DEPARTMENT OF DEVELOPMENT SERVICES – PLANNING DIVISION
REPORT: Parkville Market Phase 2 – Special Permits & Site Plan at 1390 Park Street for consideration September 27, 2022

STAFF REPORT

PROJECT: Parkville Market Phase 2
1390 Park Street (1390-1400 Park Street)
PARCEL ID: 158-403-077
P&Z-COMM-2022-0685

TYPE: Request for Special Permits and a Site Plan for Entertainment Assembly (Sec.3.3.5.K) with a Drinking Place/Bar (3.3.5.I), and an Outdoor Café associated with a Drinking Place (Sec.3.5.2.D(1)(c)) on a mixed-use property located in the CX-2 district with the Transit Oriented Development overlay per Section 1.3.4

Figure 2. North façade of the existing building w/ proposed addition – Lifecare Design 2022

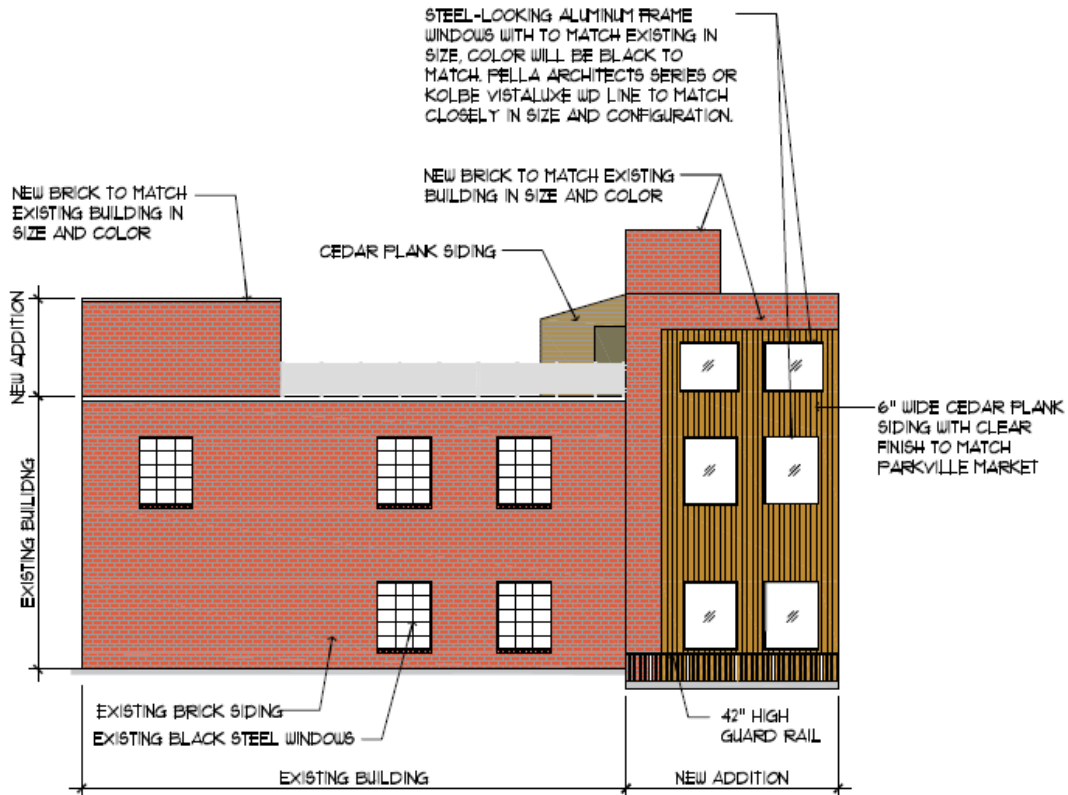
- The proposed addition will occupy space previously used as a loading dock at the northwest corner of building #1390. The addition will measure ~29’ by ~20’ and house an elevator and stairwell providing access and egress to the uses on the upper stories. See Figure 2 below for a depiction of the addition.

Figure 3. Proposed and existing uses layout – Lifecare Design 2022

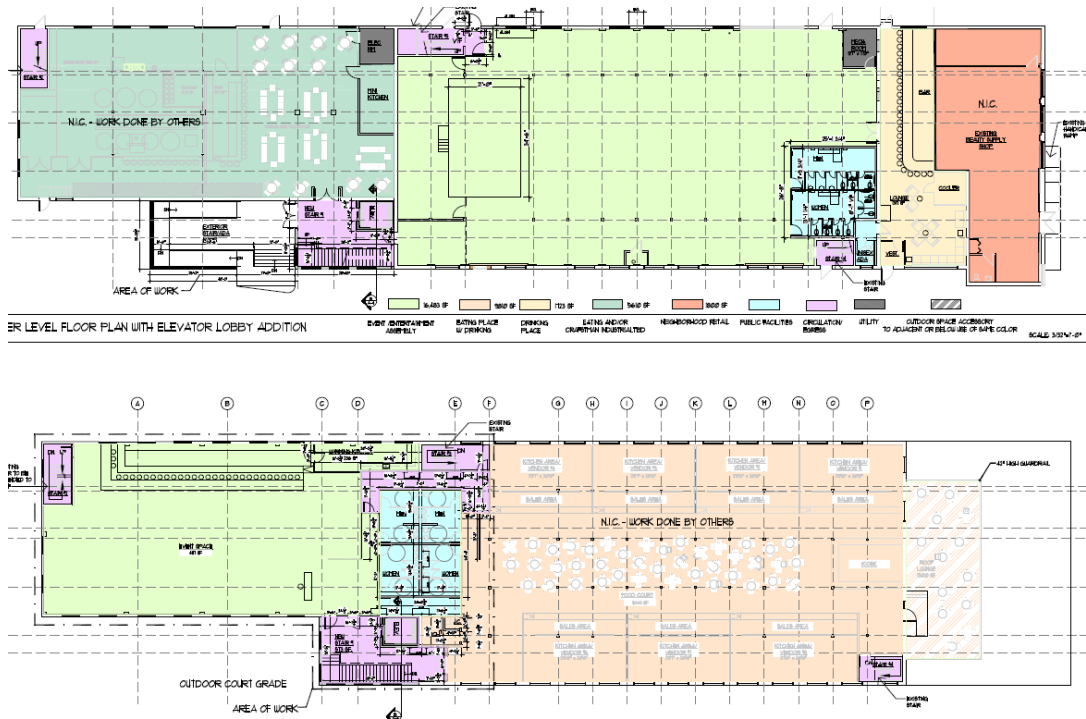
Floor Plans: Floor plans were provided by the applicant. See Figure 3 above.

1 PROPOSED SITE PLAN & ZONING INFORMATION

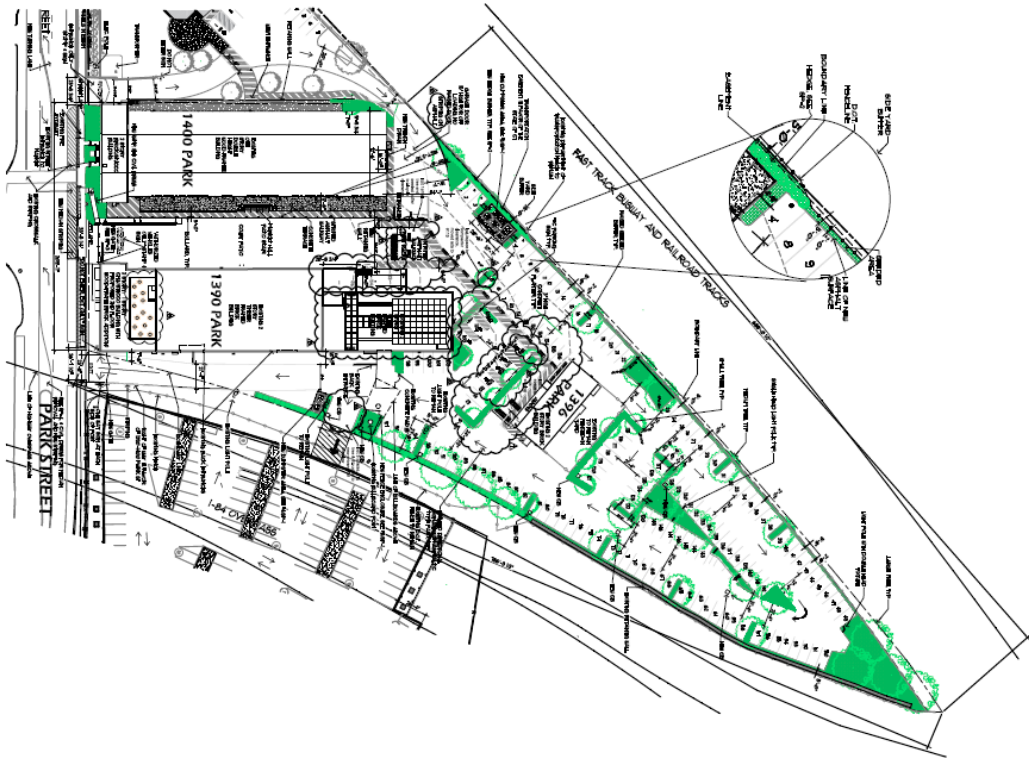
The proposed changes are generally minor and do not have significant effects on the previously approved conditions including stormwater, impervious surface, building coverage, or general site circulation. The changes include the removal of 3 trees, including one large shade tree required as part of a necessary appurtenance (dumpster, see Sec.6.12.2). The trees should be replaced on the

site and the final location and species should be approved by the City Forester. The large shade tree required as part of the dumpster landscaping should be replaced so that the requirements of Sec.6.12 are met.

The new location of the bike rack is closer to the primary entrance to the building but does not include adequate protection from vehicles such as grade separation or physical barriers. Distance separation is potentially accepted as protection per the Regulations. The bike racks are proposed to be protected from vehicles with raised planters. The proposed bike rack design appears to be an inverted-U design. This design meets the requirements of Sec.7.3.3 of the Regulations.

At a site visit in June of 2022, it was determined that the landscaping required as part of the previous site plan was not fully constructed. The landscape islands in the rear of the parking area do not contain the required deciduous trees. Per the previous plan approved in 2019, the landscape islands visible in Figure 3 below should show a minimum 6 large shade trees and 5 medium shade trees. As of the site visit on June 9, 2022, no trees have been planted. Staff recommend including a condition of approval that all plantings from the 2019 approval be installed prior to the issuance of any new building permits.

1. All trees removed as part of the current request shall be replaced on-site or payment made into the tree fund and all landscaping required of previous approvals shall be installed prior to the issuance of Certificate of Occupancy.
2. All plantings from the 2019 approval be installed prior to the issuance of any new building permits.
